The Town of Hilton Head Island
Design Review Board Special Meeting
Wednesday, May 27, 2020 – 9:00 a.m.
AGENDA

Town of Hilton Head Island
Design Review Board
March 10, 2020 at 1:15 p.m. Regular Meeting
Benjamin M. Racusin Council Chambers

1 BEDROOM BUILDING

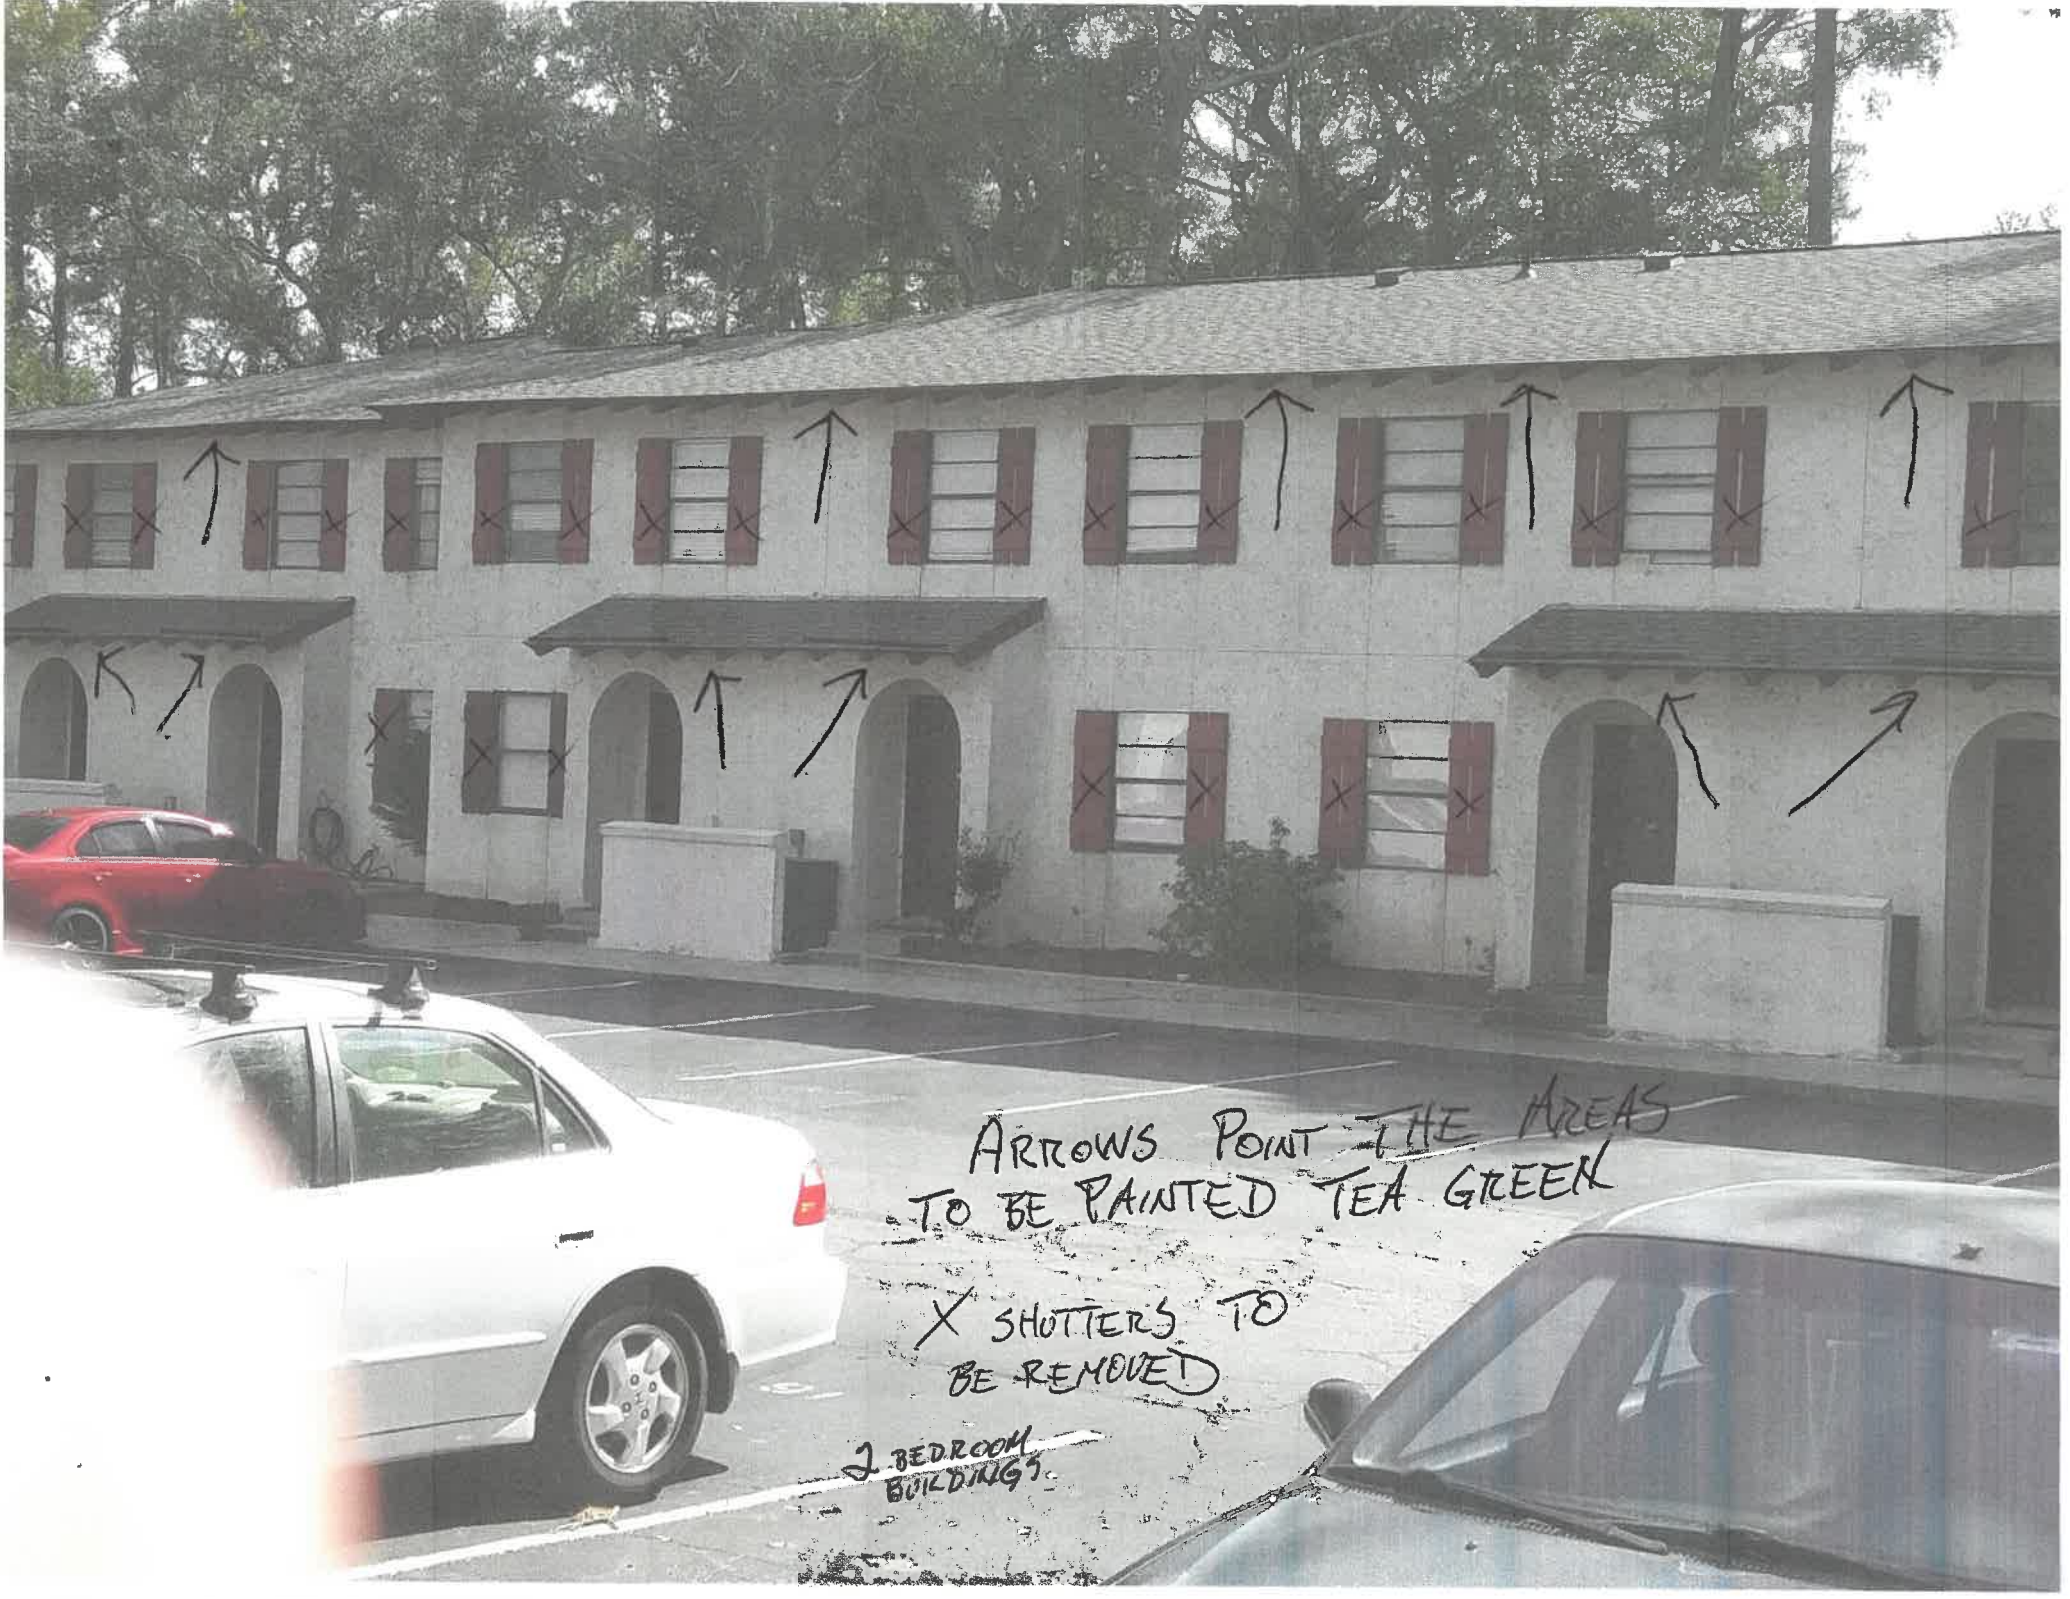
ARCHITECTURAL DESIGN				
DESIGN GUIDE/LMO CRITERIA	Complies Yes	No	Not Applicable	Comments or Conditions
Avoids monotonous planes or unrelieved repetition	<input type="checkbox"/>	<input checked="" type="checkbox"/>	<input type="checkbox"/>	Staff is concerned that the removal of the wood shutters will eliminate a detail that breaks up an otherwise monotonous façade. Staff suggest but not require the shutters be repaired and kept. See letter from POA.
Forms an details are sufficient to reduce the mass of the structure	<input type="checkbox"/>	<input checked="" type="checkbox"/>	<input type="checkbox"/>	See comment above.
Utilizes a variety of materials, textures and colors	<input type="checkbox"/>	<input checked="" type="checkbox"/>	<input type="checkbox"/>	The proposed colors are nature blending and in-keeping with the Design Guide but too similar. Staff would suggest there be a greater difference in the colors to add more interest to the buildings. The application has been altered to eliminate “Brainstorm Bronze” and replace with “High Tea”

MISC COMMENTS/QUESTIONS
To clarify the narrative, SW 6159 High Tea is the proposed trim color and SW 7033 Brainstorm Bronze is the proposed door color. These proposed colors do not scan well but physical color samples are available at Town Hall if you would like to view them. Photos of the balcony, pool fence and clubhouse have been added. Scope and project timing clarified in email dated May 12th (see Documents)

REVISIONS	
1. ADDED FIXTURES D & E	4.8.20
2. CHANGED FIXTURE FINISHES TO GALV.	4.8.20
3. RAN EXPOSED CONDUIT	4.8.20
4. CHANGED SPEC ON FANS	4.8.20
5. ADDED WINDOW AT BAR IN R.O.	4.8.20
6. ADDED GOOSE NECK LIGHTS	4.8.20
7. ADDED SPEC ON WALL MOUNT FANS	4.8.20

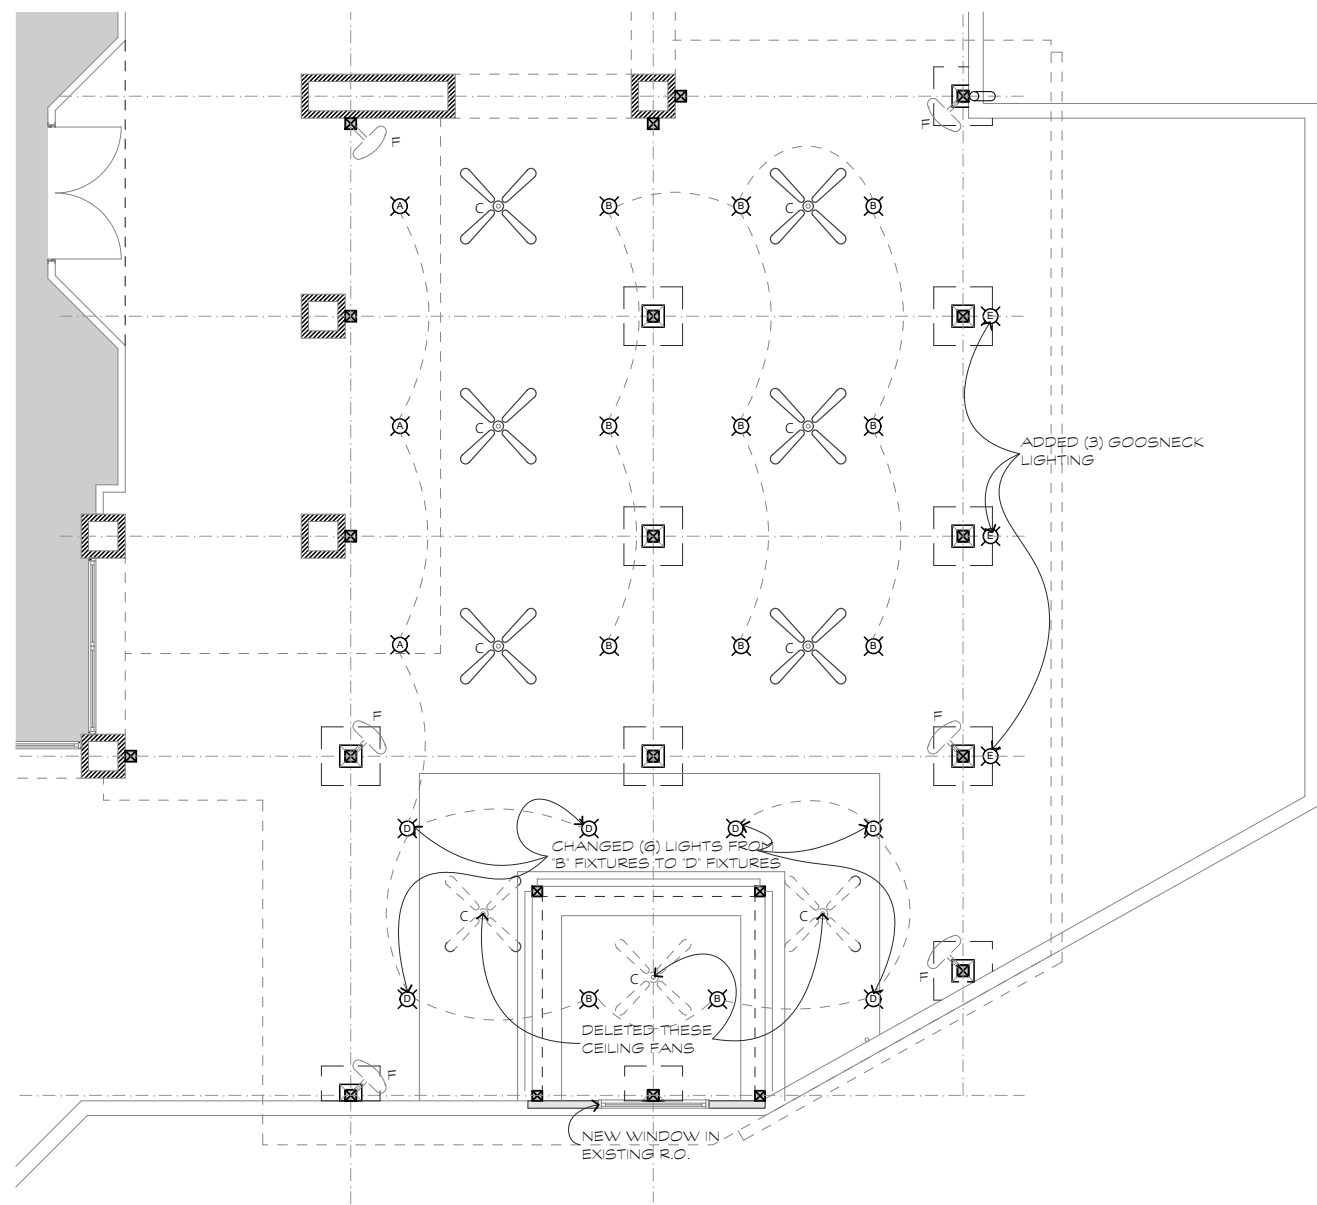
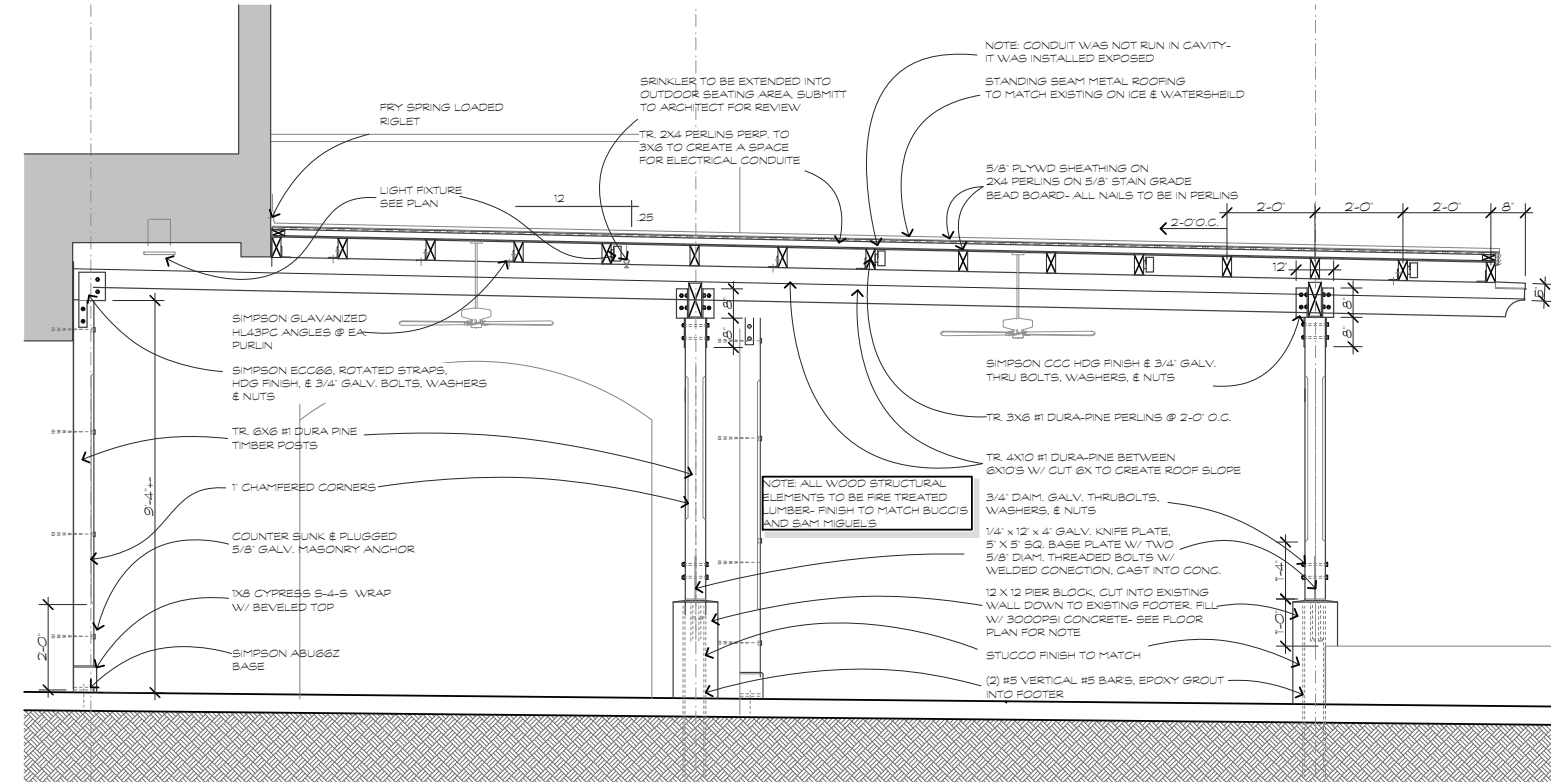
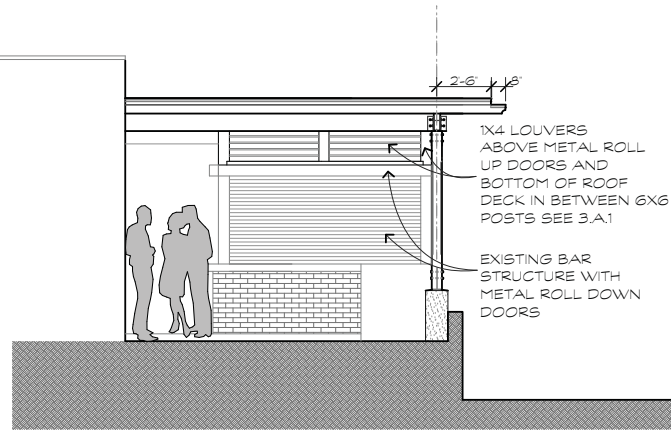
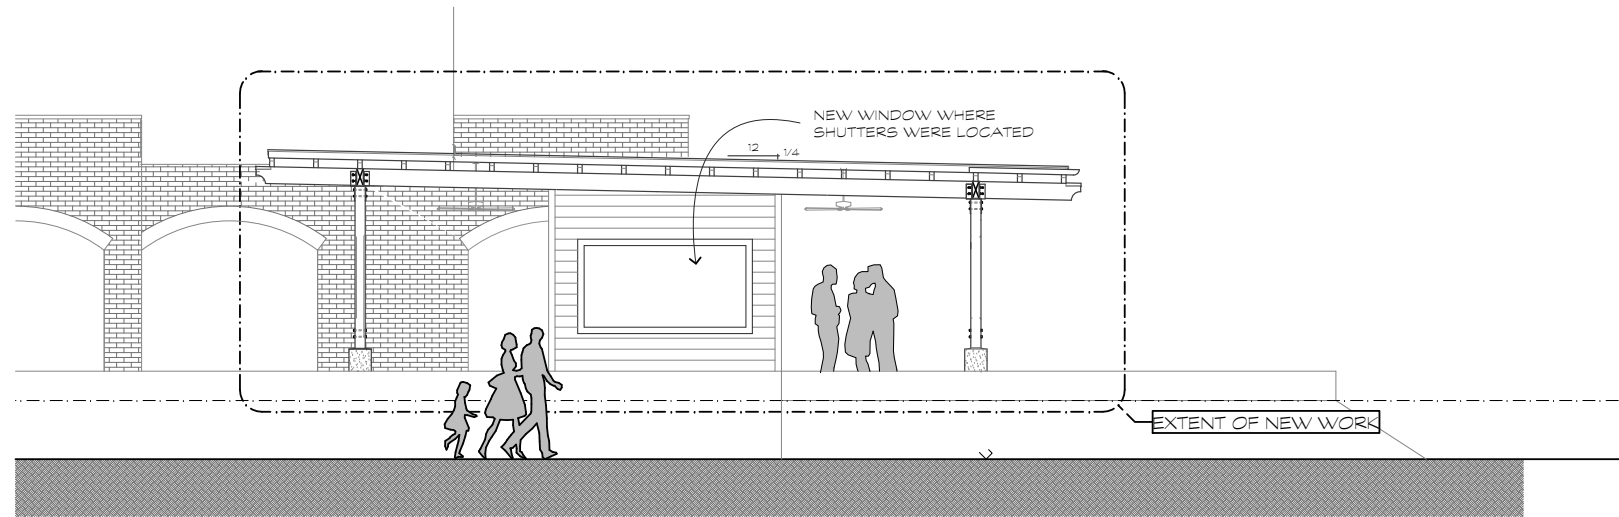
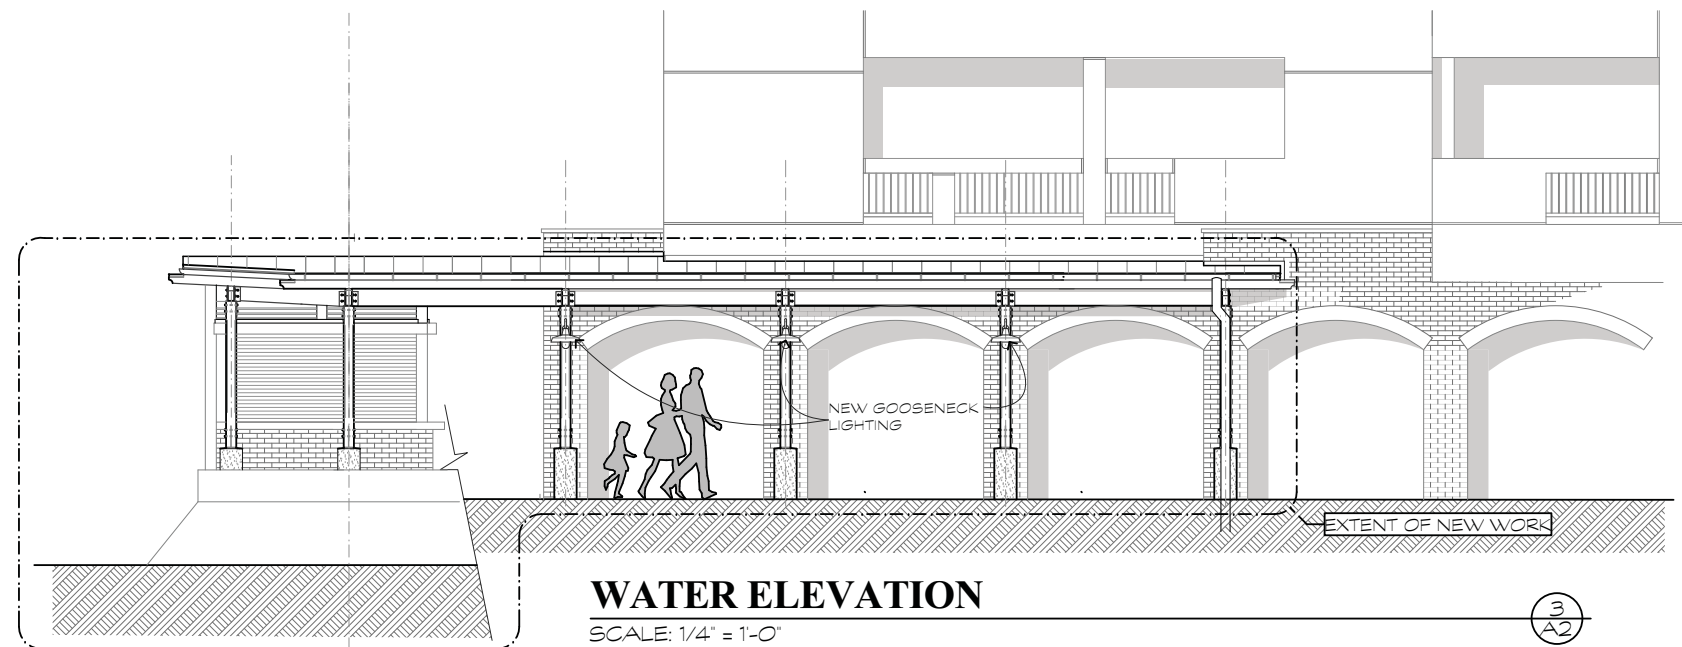
3. The cylinder lights as approved by the DRB provide lighting with a shielded light source, in keeping with the LMO Sec. 16-5-108 C.1. "The Light source shall be completely concealed within an opaque housing...". The lights installed do not meet the LMO requirements.

4. The approved DRB plans do not include a window in the back wall of the bar area. The window seems out of place and foreign.
5. The DRB approval is specific about concealing the electrical conduit and sprinkler lines, see DRB Conditions 2 and 4 of the Oct. 15 2019 NOA.

1. All lighting fixtures not approved by the DRB shall be removed.
2. All fans shall be replaced to meet DRB approved specifications.
3. Box fans are approved as installed.
4. Add a Bermuda shutter to the bar window. Submit color to Staff for review and approval.
5. Electrical conduits and sprinkler lines shall be concealed. Submit concept to conceal conduits and lines to Staff and one DRB member for review and approval.
